AmerGen Energy Company, LLC
Oyster Creek
US Route 9 South
P.O. Box 388
Forked River, NJ 08731-0388

Subject: Oyster Creek Generating Station
Docket No. 50-219
Facility Operating License No. DPR-16
Technical Specification Change Request No. 281
Supplement to Response to Request for Additional Information

Supplement to Response to Request for Additional Information

Figure 1 - Elevation View of Typical End Truck and Bridge Connector Member

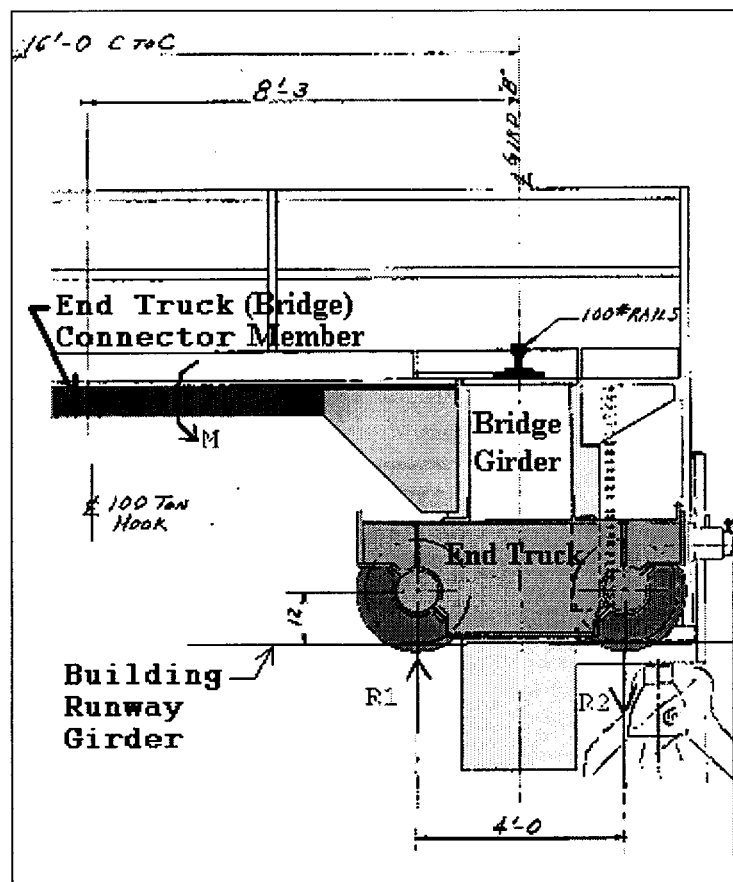
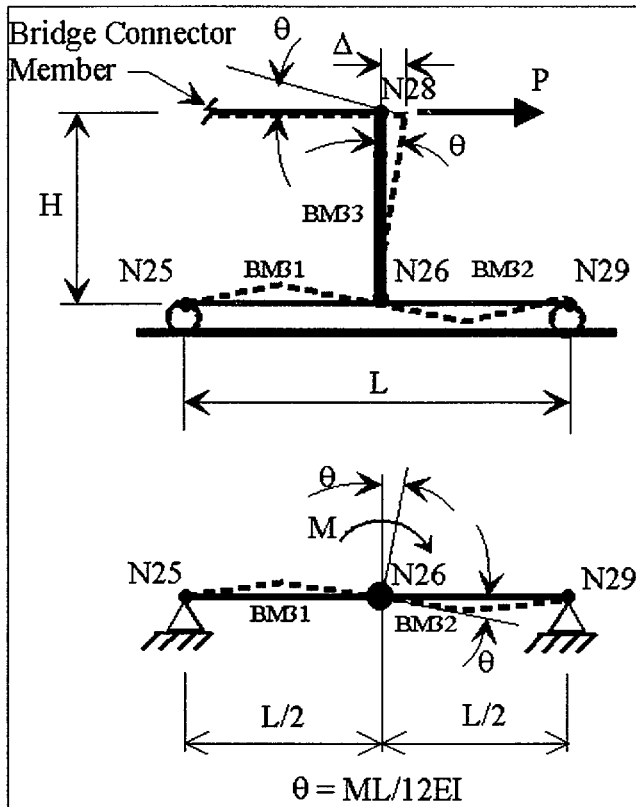
Attachment H, Page H10: How much does the stress interaction ratio exceed 1.33?

Describe the energy absorption method used to justify that the member in Question 5 is adequate.

The energy absorption technique determined the plastic hinge rotation capacity using commonly accepted engineering principles and compared it to the demand placed on it. A method of checking the plastic hinge rotation demand versus capacity is to compute the moment that would be required to deform the end truck to the point where the rotation in the connector member reaches its plastic hinge rotation capacity then compare the computed moment against the moment resulting from the seismic analyses. If the seismic analysis moment is smaller, then the rotation demand on the connector member is less than its capacity.

A free-body diagram representing one of the bridge end trucks and connecting members (illustrated in Figure 1 above) is shown below on Figure 2. Node and element numbers corresponding to the STARDYNE finite element model are marked on Figure 2. Note that the vertical stick member (BM 33) representing the cross section of the bridge girder is modeled as a

very stiff element. The rotation at the top of the truck, θ , is equated to the plastic hinge rotational capacity and the moment at the base of the vertical stick (Node 26) is computed. This calculated moment is then compared to the design moment in Beam 33 at Node 26.

Figure 2 - Free Body Diagram Relating Flexural Rotation in Bridge Connector Member to Moment in End Truck Members

Allowable rotation, θ_a , is a calculated quantity based on the plastic hinge rotation capacity of the bridge connector member and an appropriate factor of safety. The allowable plastic hinge rotation is calculated as follows:

- Set the extreme fiber strain equal to 1/4 of the ultimate tensile strain of the material.
- Relate this fiber strain to a curvature based on the geometric properties of the cross section.

- Determine the hinge rotation by factoring the curvature by the plastic hinge length.

The next step is to relate the allowable curvature, θ_a , to an allowable bending moment, M_a , at the base of the 'vertical stick' in the free body diagram. This goal is accomplished by solving the flexural rotation equation of a simply supported beam with a concentrated midspan moment, $\theta = ML/12EI$ for the moment, M . Length, L , elastic modulus, E , and moment of inertia, I , are known quantities of the lower horizontal member representing the truck in the free body diagram.

Allowable moment $M_a = (12EI\theta_a/L)/FS$ at the base of the 'vertical stick' in the free body diagram represents the allowable energy absorption capacity of the bridge connector member where FS represents an additional factor of safety of 1.6.

Once the 'capacity' is known in terms of the moment at the base of the end truck, a corresponding demand can be obtained directly from the seismic analyses. Demand is simply the maximum computed moment at the base of the bridge girder member (Beam 33 at Node 26) obtained from the seismic analyses. The resulting demand versus capacity ratio, including the indicated factors of safety on the capacity, equals 0.0014. This large reserve margin of plastic hinge rotation capacity indicates that permanent deformations may occur under the SSE loading conditions but structural integrity of the bridge connector member is maintained.
